Re: North Campus Facilities

Subj: Change Proposal No. 233901-0011

Williamson County – North Campus Facility

ASI #08 – 4/10/2017

4 1st FLOOR - STAIR 1-ELEVATOR
1/4" = 1'-0"

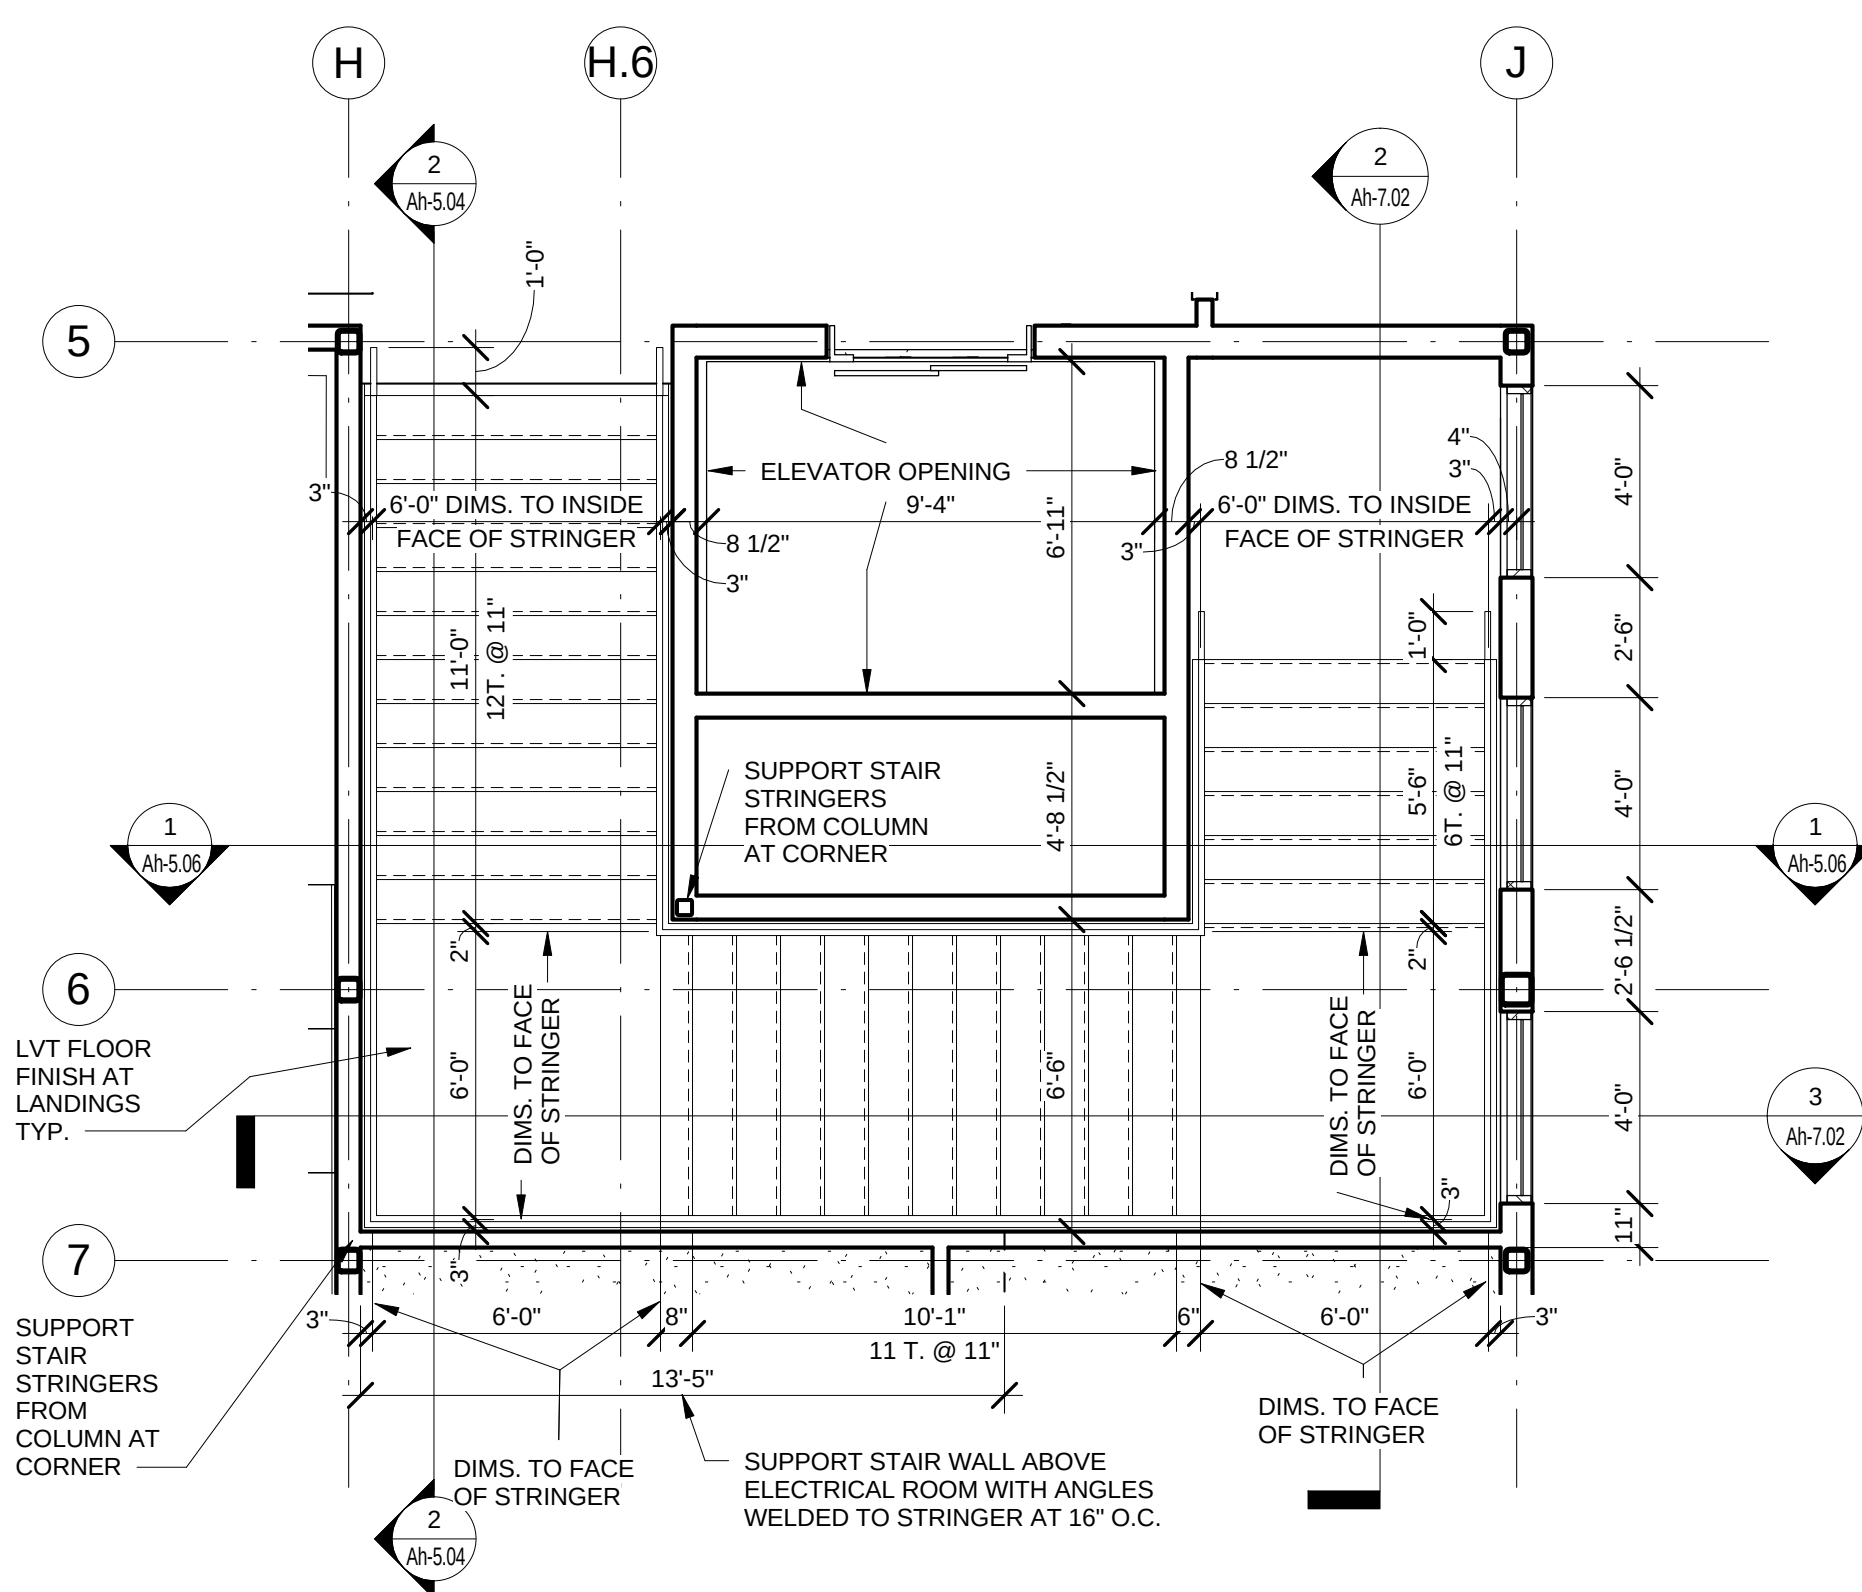
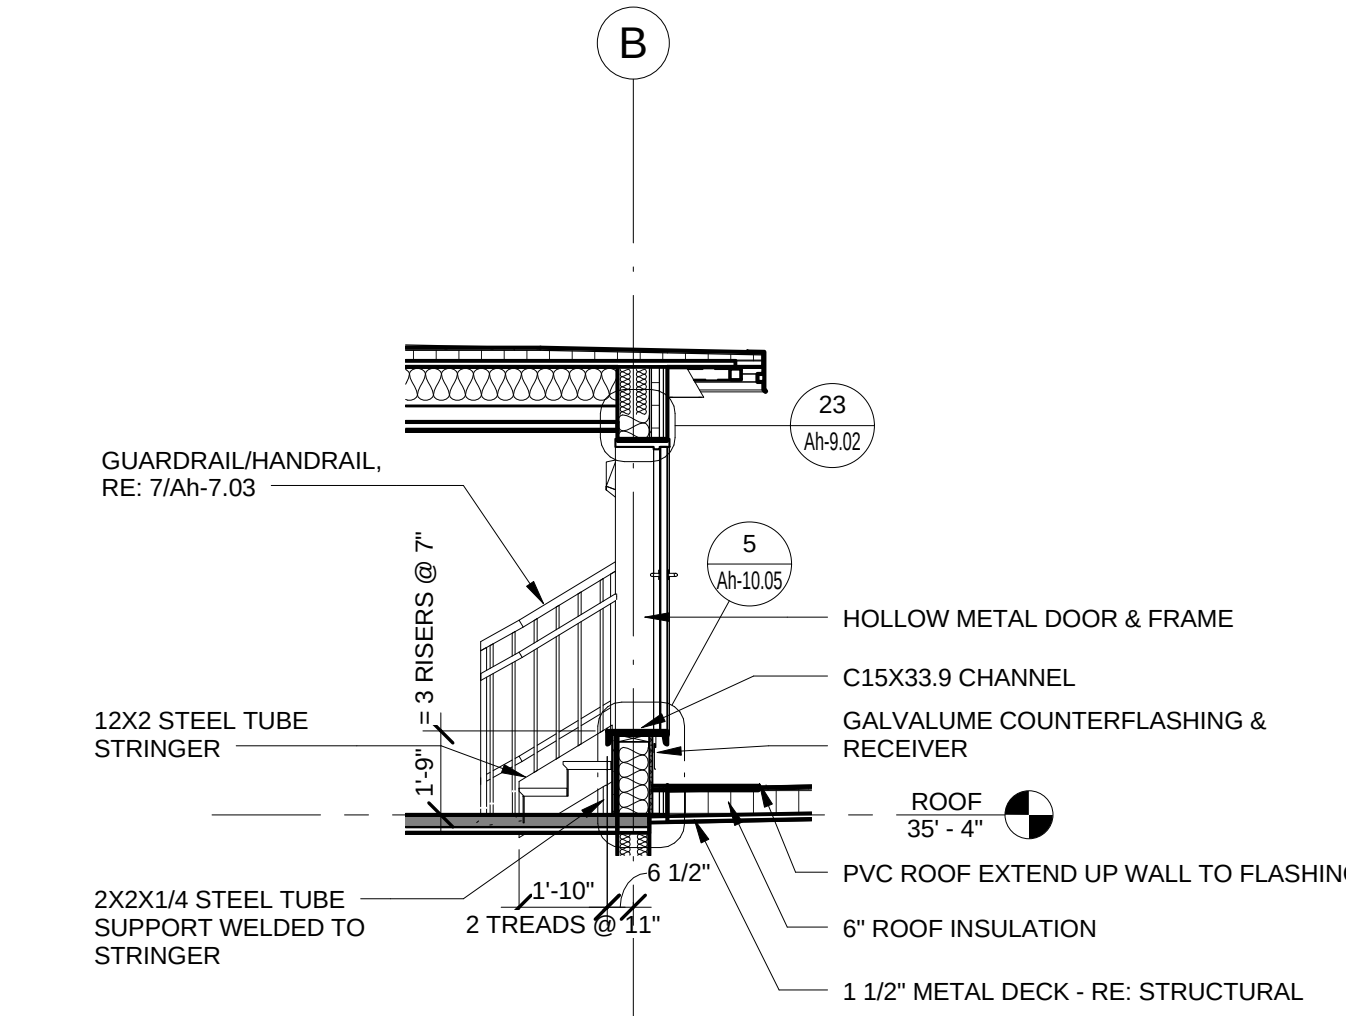
Please provide the hoist beam section size, location and connection details, as indicated in the attached sheet Ah-7.02.

Refer to attached details for structural steel posts and tube framing to support the hoist beam and to support the elevator guide rails as required by the elevator manufacturer.
